Subject: **Response to NCDWR On-Hold Letter dated July 19, 2016** for the proposed widening of NC 273 (South Main Street) from Tuckasee Road to Highland Street in Gaston County, Federal Aid Project No. STP-273-(1), Division 12, TIP No. U-3633, WBS 37649.1.1.

Reference: 404/401 Individual Permit Application dated July 8, 2016
NCDWR On Hold Letter dated July 19, 2016

Revised Table 1 – U-3633 Stream Impacts**

PERMIT DRAWING
SHEET 7 OF 11

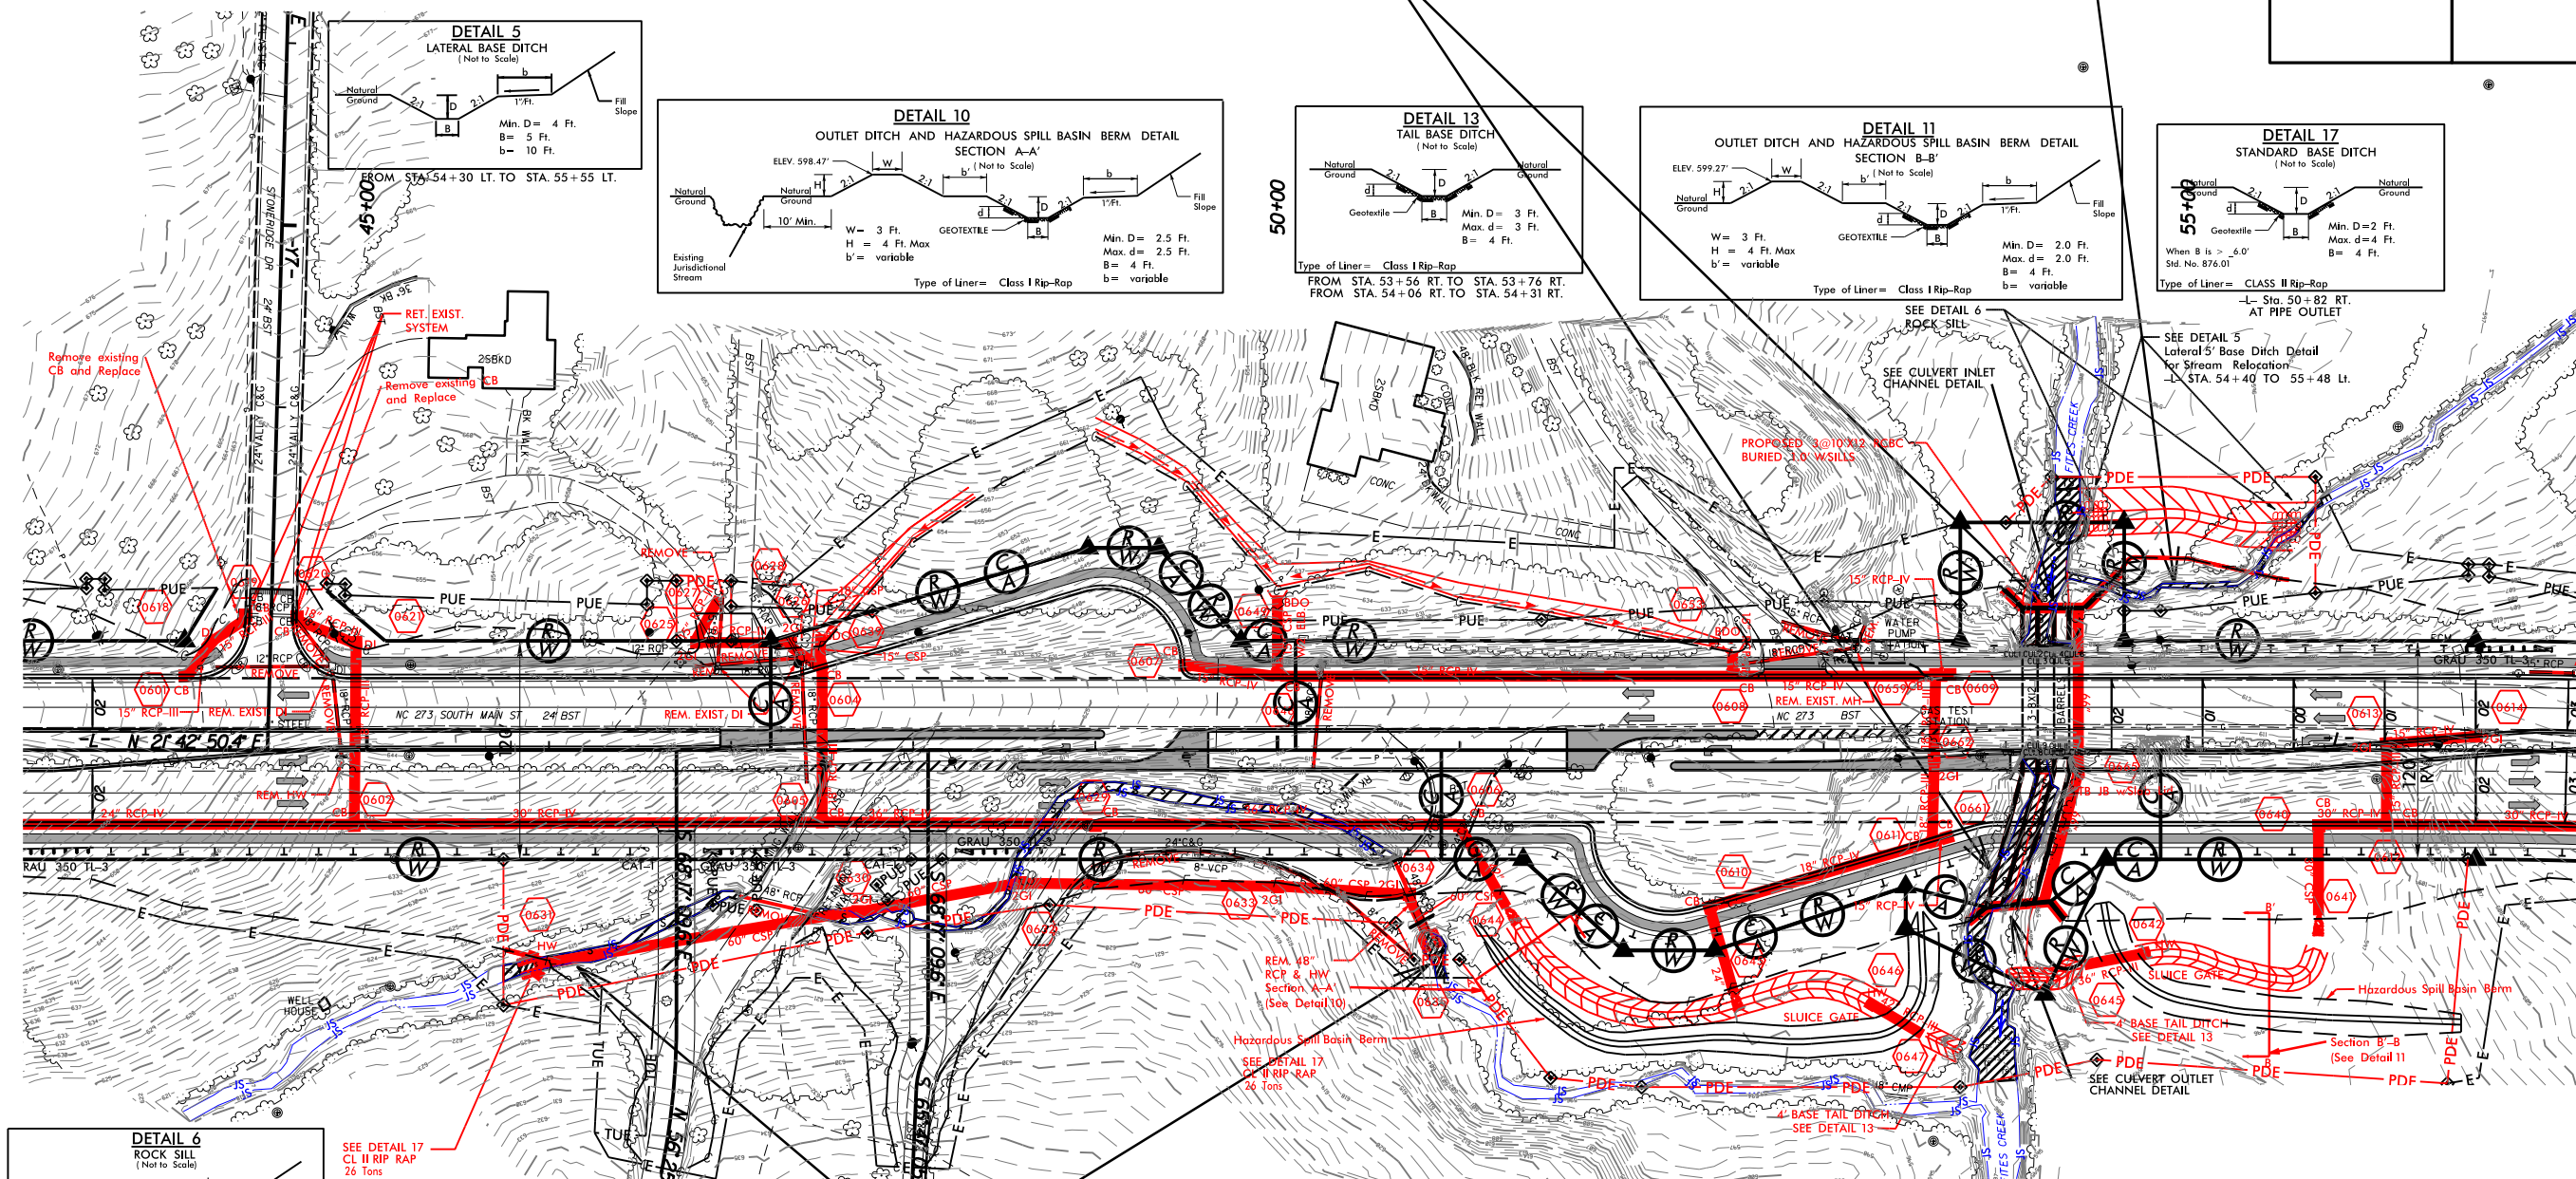
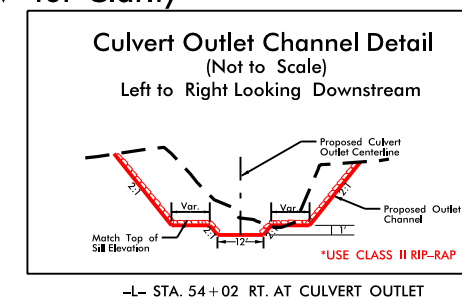
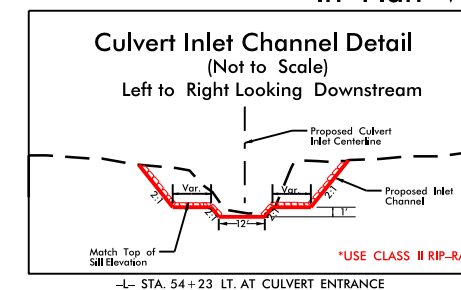
- 1) All riprap in jurisdictional areas has been upgraded to Class II.
- 2) No details referencing jurisdictional streams show geotextile fabric on the bed of the stream.
- 3) Inlet stabilization has been added to permit sites 1, 3, 4, and 5 (and impact summary sheet has been revised accordingly).
- 4) More detailed floodplain bench details for Fites Creek have been provided.
- 5) The rock sill detail (detail 6) for permit site 7 has been updated.
- 6) The easement line near the pond will be changed from a PUE (Permanent Utility Easement) to a DUE (Permanent Drainage/Utility Easement) to allow for better erosion control associated with installing a 24" drainage line next to the pond.
- 7) Temporary dewatering impacts for each site have been incorporated into the impacts.
- 8) Any riprap used in stream beds will be embedded.

SEE DETAIL 17
CL II RIP RAP
2' T

NOTE:
CL II Rip Rap Not Shown
in Plan View for Clarity
